**IN THE MATTER OF THE
REQUEST FOR MODIFICATION
TO THE FENCING TYPE
APPROVED WITH THE FINAL
PLAT FOR SOUTHRIDGE SOUTH
NO. 1 ALONG THE RIDENBAUGH
CANAL.**

CASE NO. MFP-2025-0002

**ORDER OF CONDITIONAL
APPROVAL OF FINAL PLAT
MODIFICATION**

SUBJECT: Southridge South No. 1
MFP-2025-0002

B. Proposed Landscape Plan with 6-foot-tall black wrought iron fence along Ridenbaugh Canal

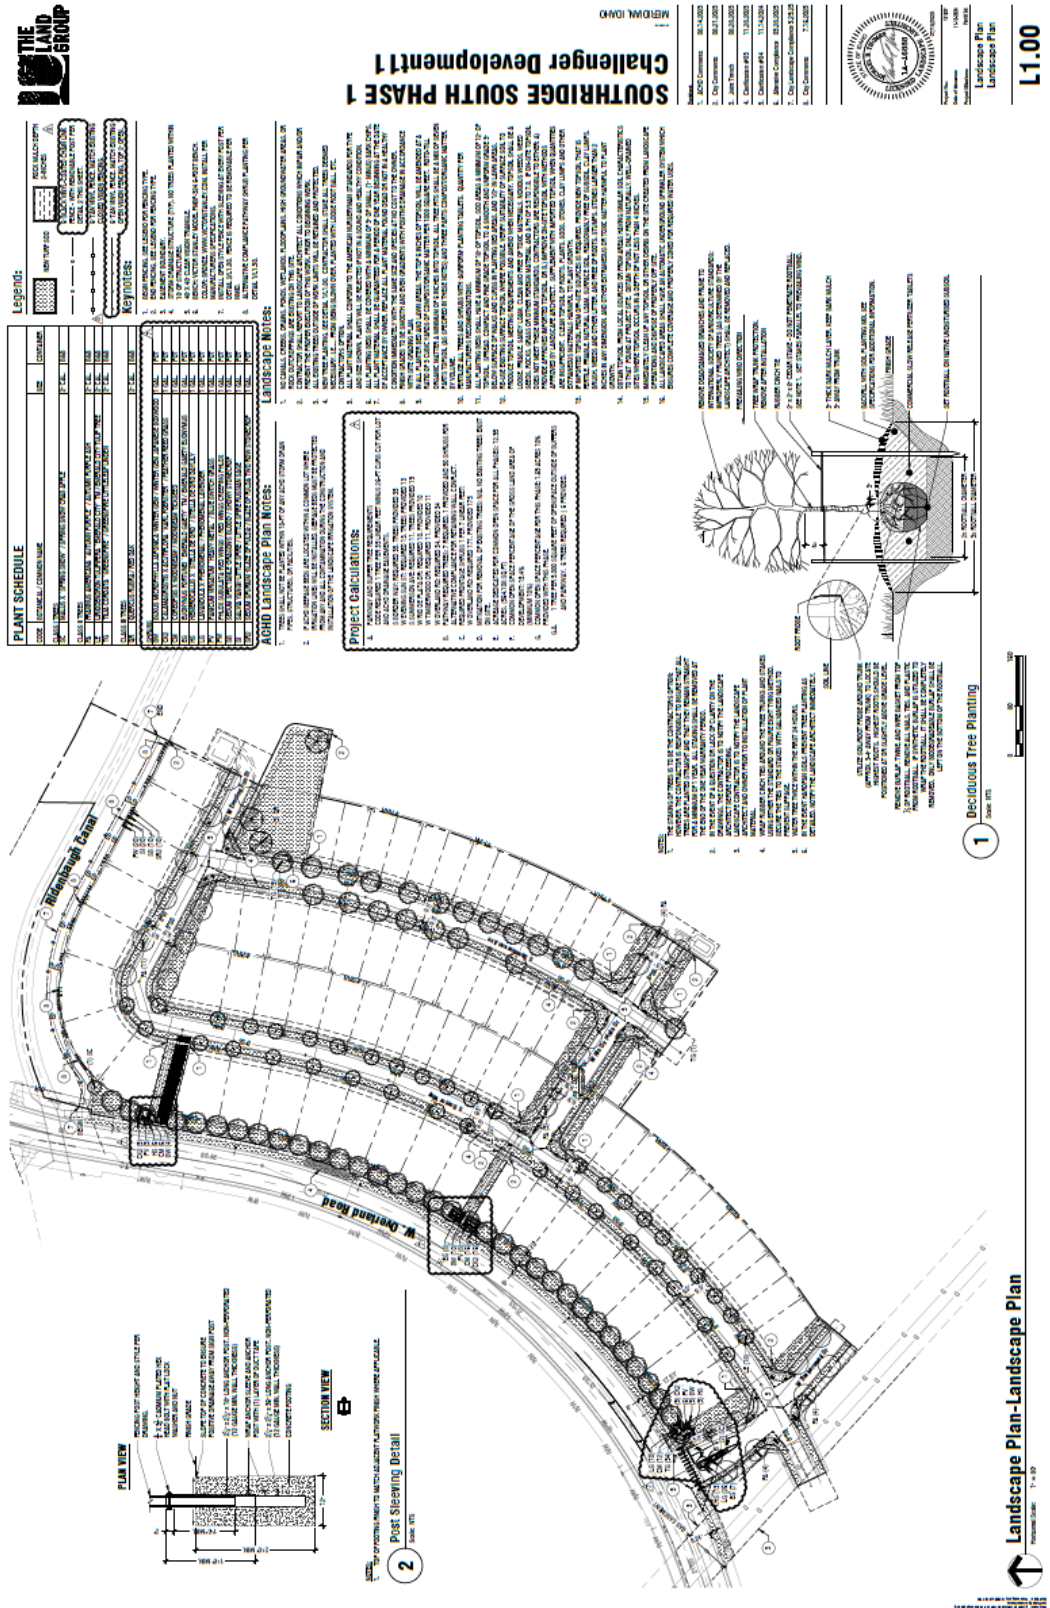
The fencing type along the Ridenbaugh Canal shall be black ~~wrought iron~~ open vision vinyl-coated chain link as ~~required~~ approved by City Council with MFP-2025-0002; depict accordingly.

The fencing type along the Ridenbaugh Canal shall be black ~~wrought iron~~ open vision vinyl-coated chain link as ~~required~~ approved by City Council with MFP-2025-0002; depict accordingly.

City Council approved the Applicant's request as proposed.
